Quality Assurance Program Description
for the
Design and Construction of the
South Texas Project
Revision 6
Principal Changes

Part A, Houston Lighting & Power Company (HL&P QAPD)

SOUTH TEXAS PROJECT ELECTRIC GENERATING STATION
QUALITY ASSURANCE DURING DESIGN AND CONSTRUCTION

REVISION 6

FIGURE 1

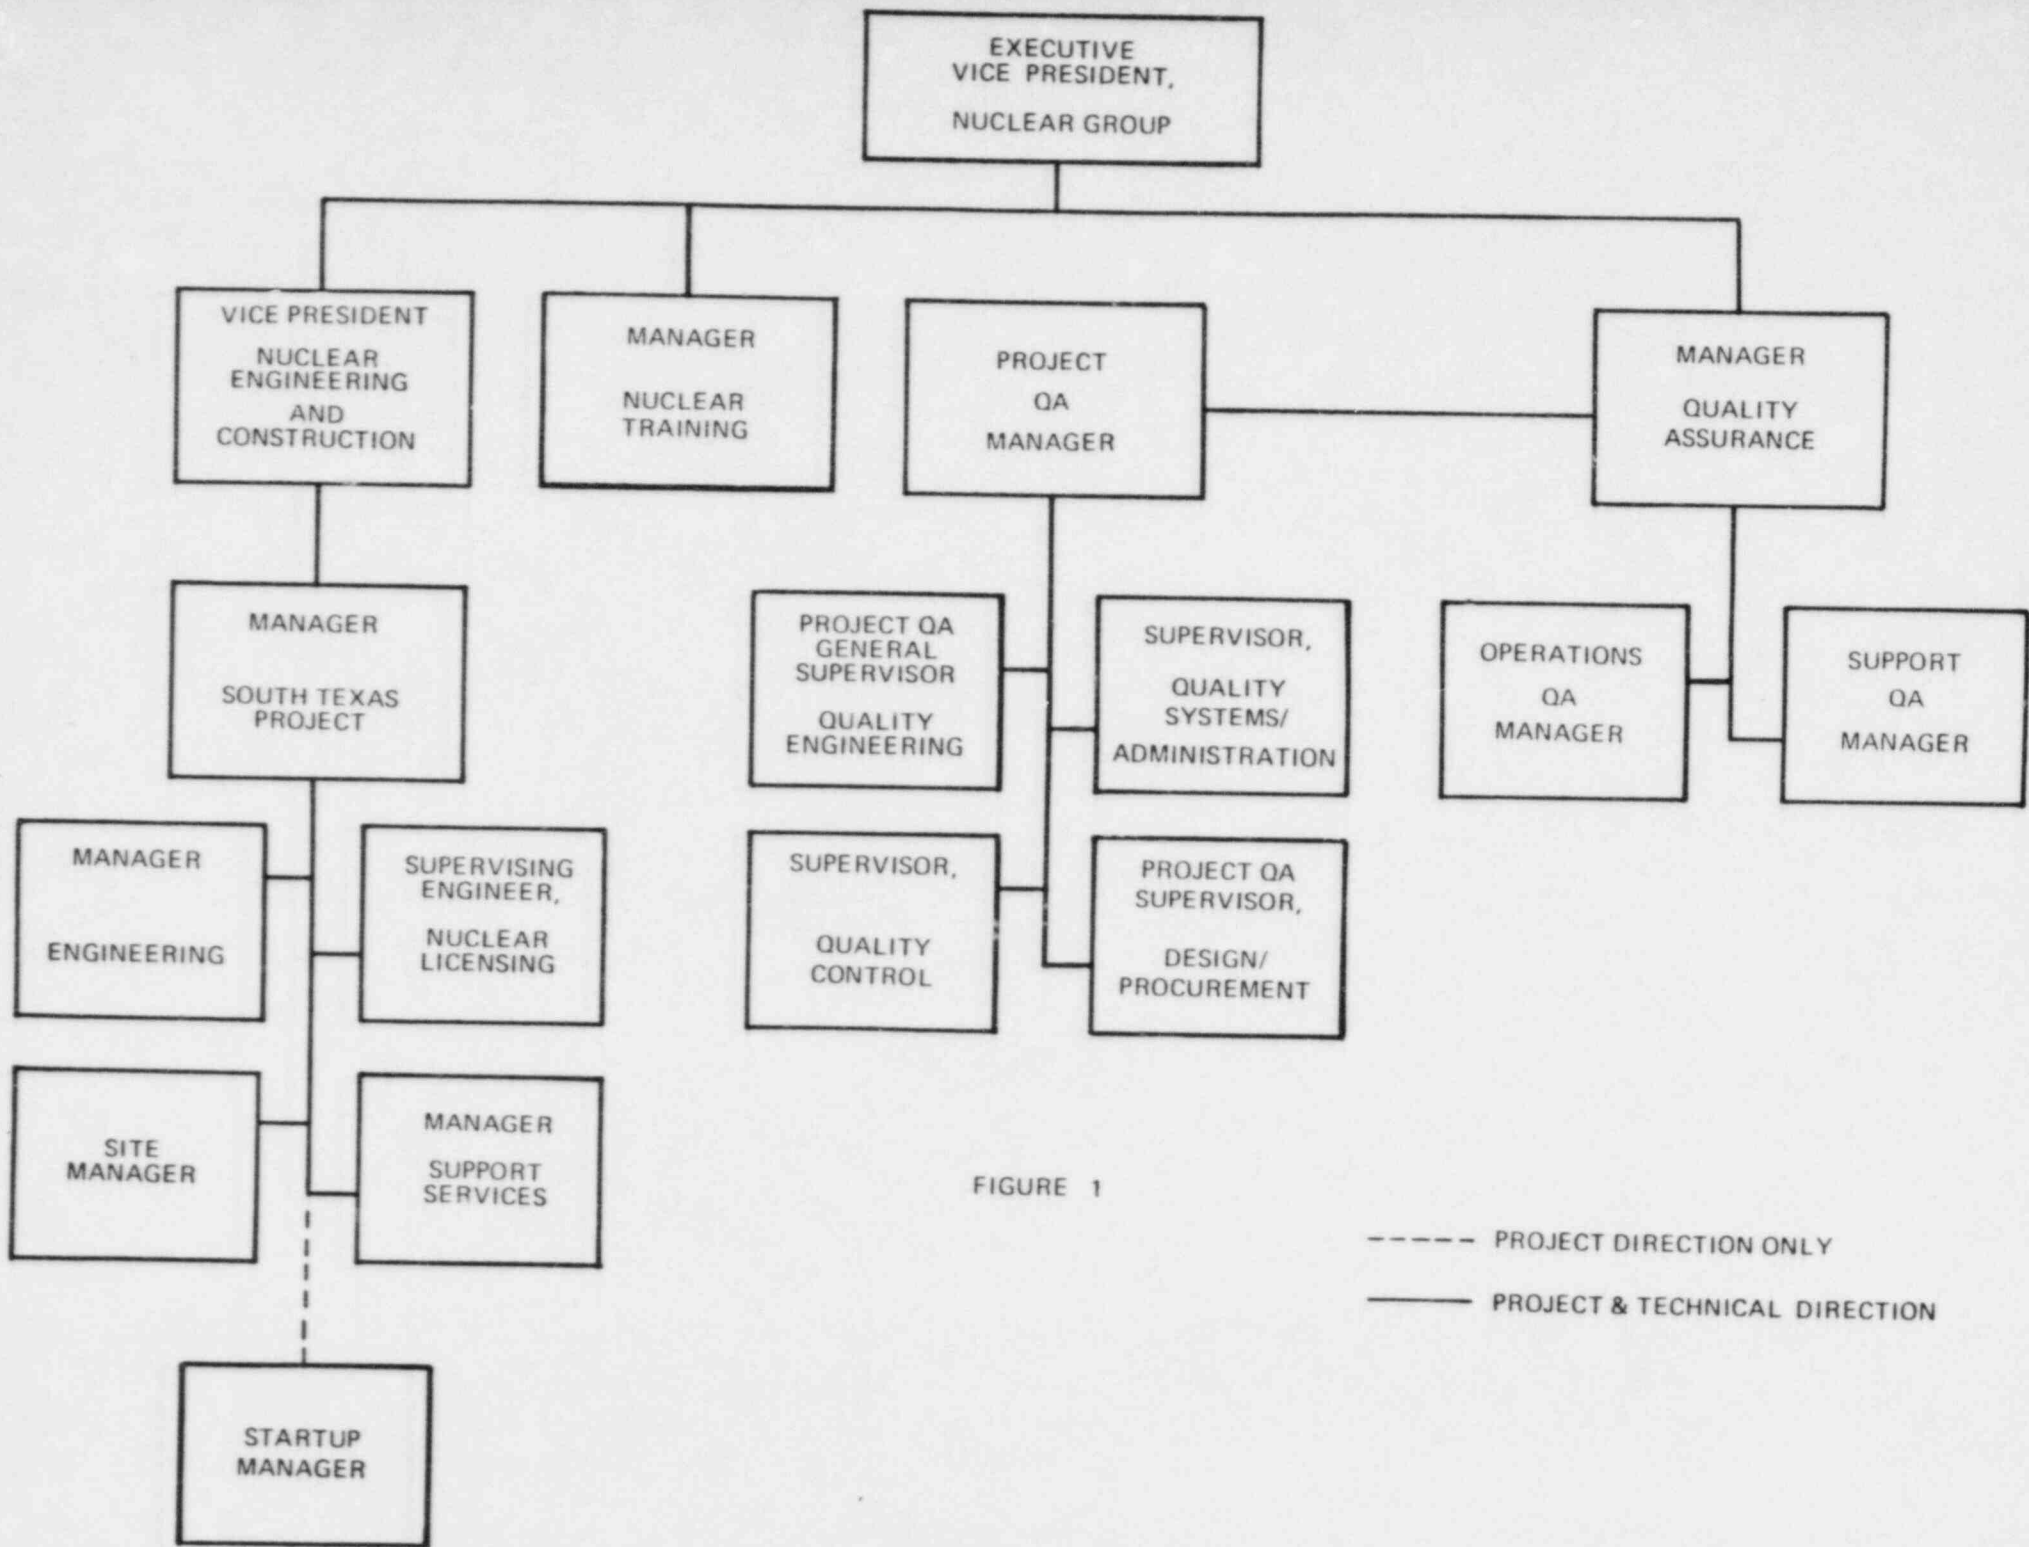
Pages 3, 7, 12 and Figure 1 have been revised to reflect the formation of a centralized Nuclear Training group to direct, coordinate and administer the STP Nuclear Training efforts. This change was made to maximize the use of available training resources and to minimize redundancy inherent in the use of separate, departmental training groups. No reduction in commitments previously contained in Revisions 4 and 5 of the QAPD have been made.

Page A-4 - item #2 - second paragraph

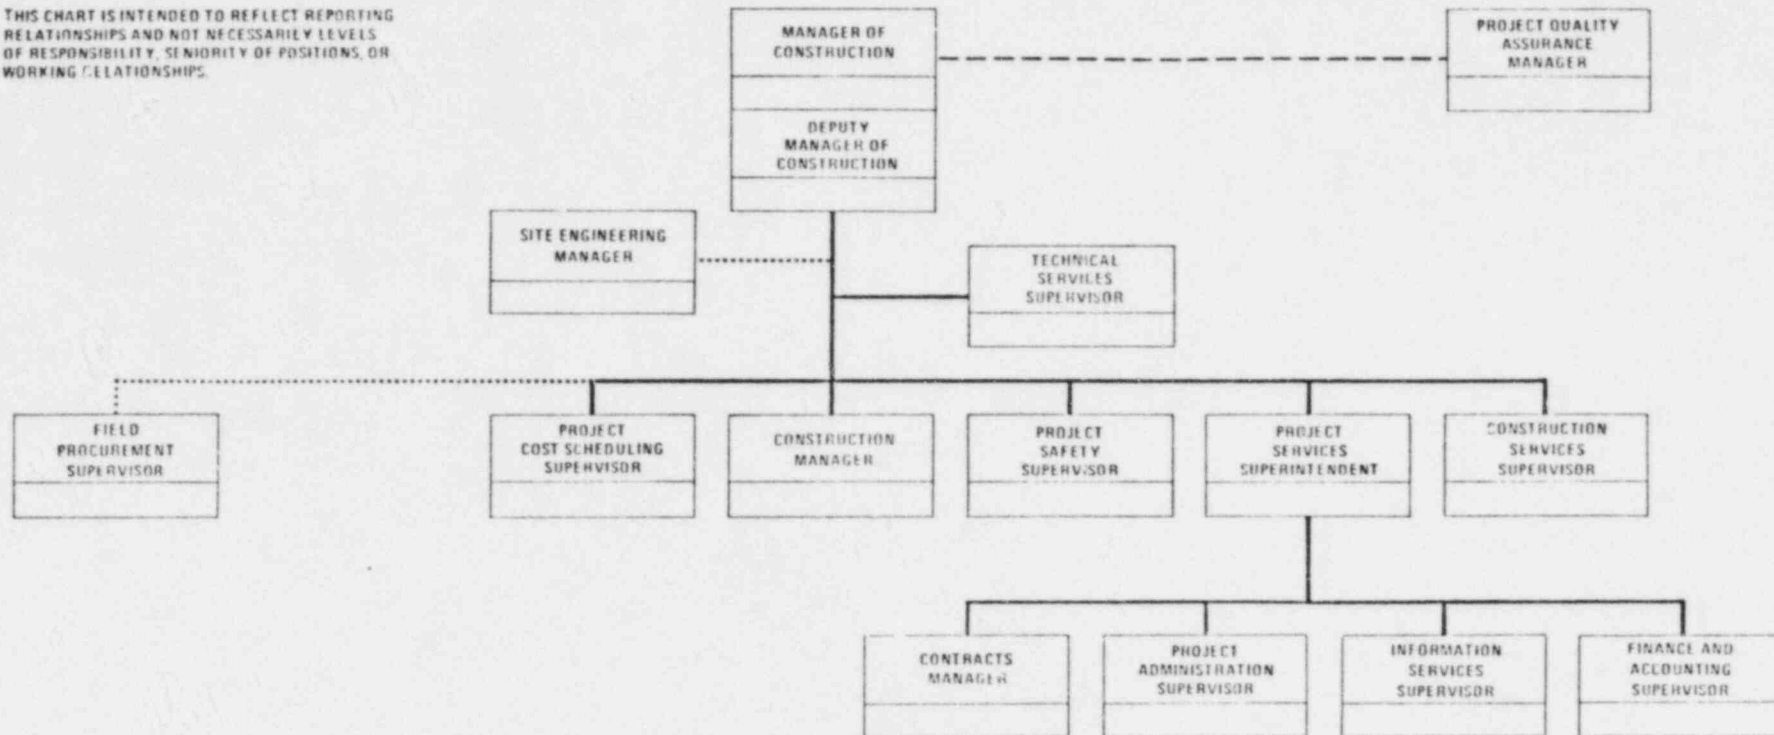
Appendix A, Page A-4 was revised to clarify access limits and posting requirements for Level D storage areas. This change was made to eliminate uncertainty in the posting requirements for access control for Level D storage areas. The statement in the QAPD, Revision 4, requiring Level D access controls consistent with Zone IV areas as defined by ANSI N45.2.3, i.e. no personnel accountability, was revised to require posting of storage level designation only in Level D areas. No reduction in commitments contained in revisions 4 and 5 to the QAPD have been made.

"Access to storage areas for Levels A, B, and C will be controlled by the individual(s) responsible for material storage. While the above areas will be posted to limit access, other positive controls (other than that for the overall site area) or guards may not be provided. Level D areas will be posted with the storage level designation only."

FIGURE I-2.4
REV. 3-STP

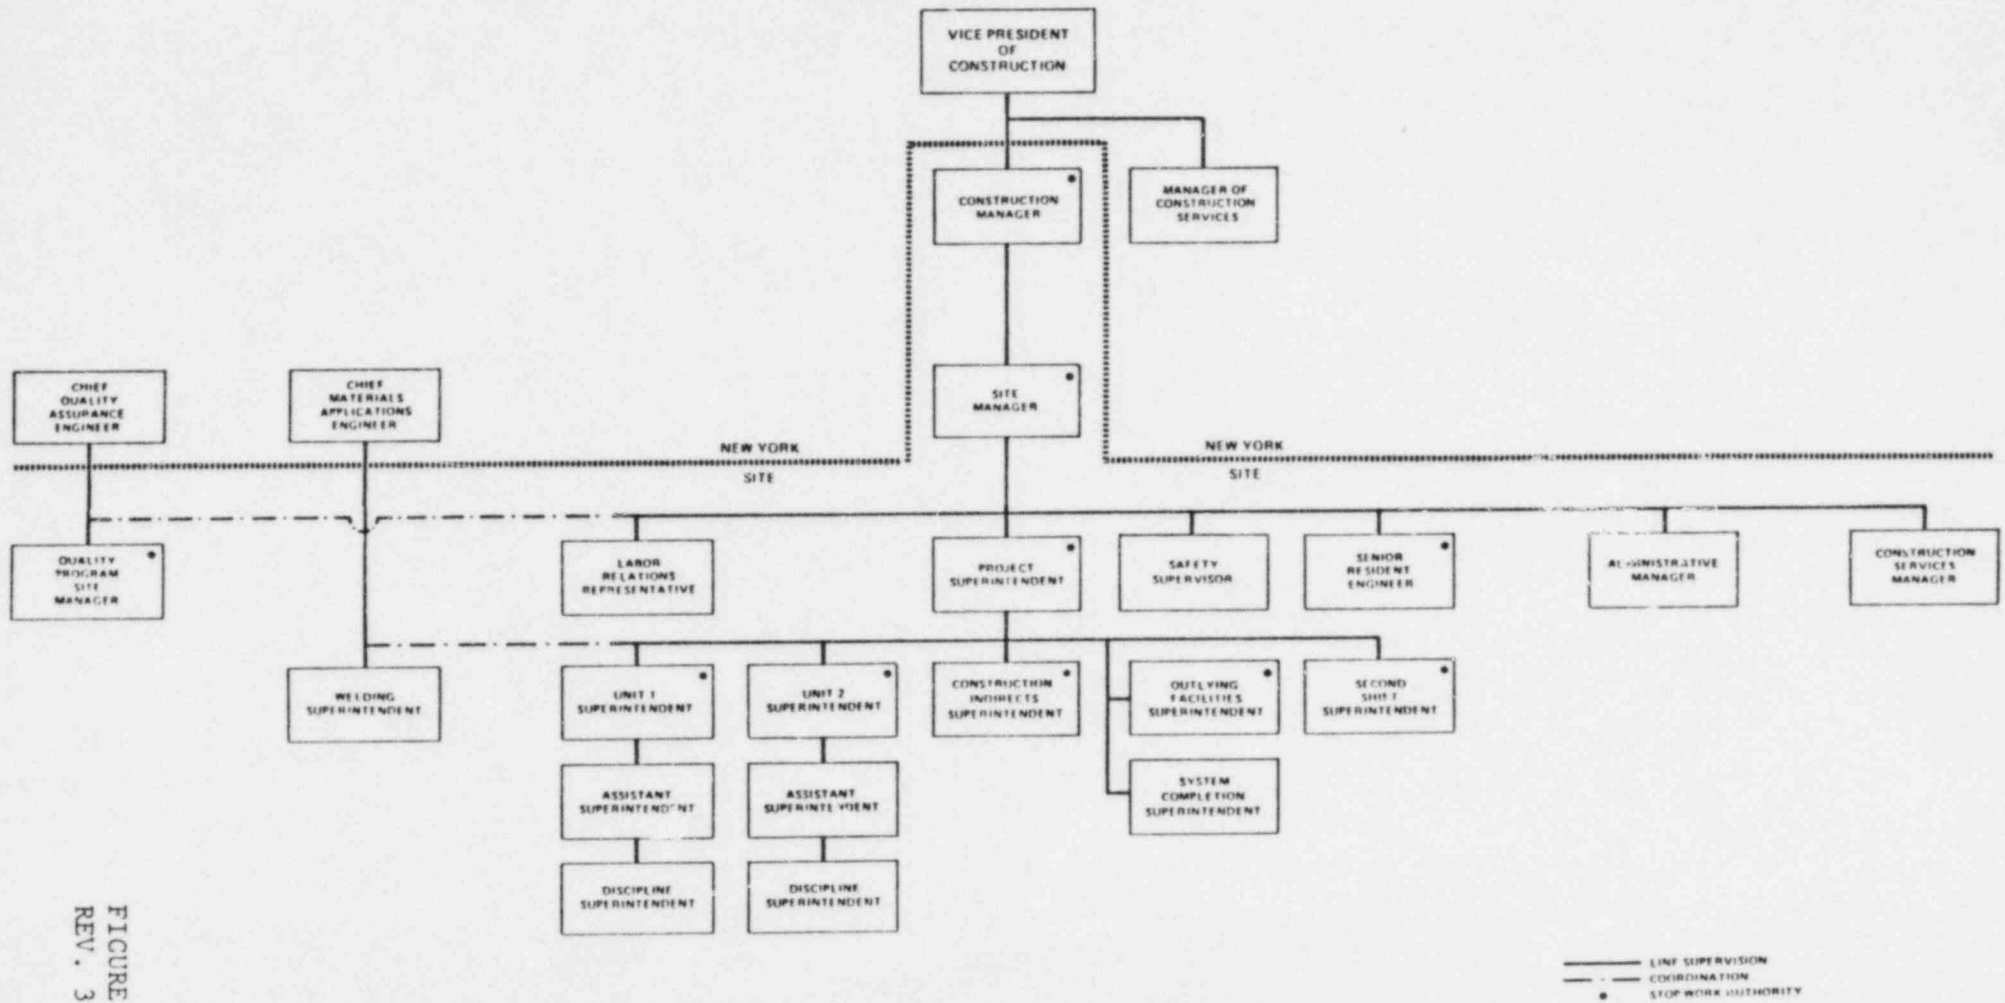
Revised to reflect organization changes/deletions indicated in subparagraphs of Paragraph 4.0.
